# **Kennington Park Intervention** Figure 5.9A Kennington Park - Circulation Diagram and Ventilation Shaft

# Addendum to Appendix: Heritage Statement

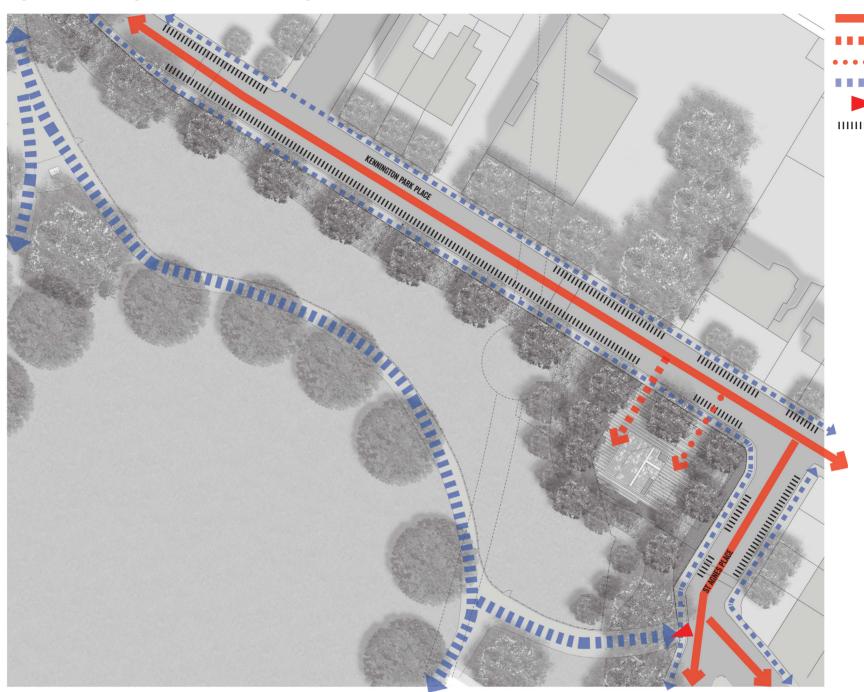
The text below replaces paragraph 5.7.4:

Plant replacement will be via a hatch between the head house and the community building which in the area immediately east of the head house and will be paved. This will be 'broken out' when access for major improvement equipment is required and then replaced. This would be an infrequent event, probably once in every 20 years and access from Kennington Park Place for removal/ installation of this equipment would be via a demountable fence panel on the northern edge of the site.

Figure 5.9 Kennington Park – Circulation Diagram has been replaced with Figure 5.9A Kennington Park – Circulation Diagram.
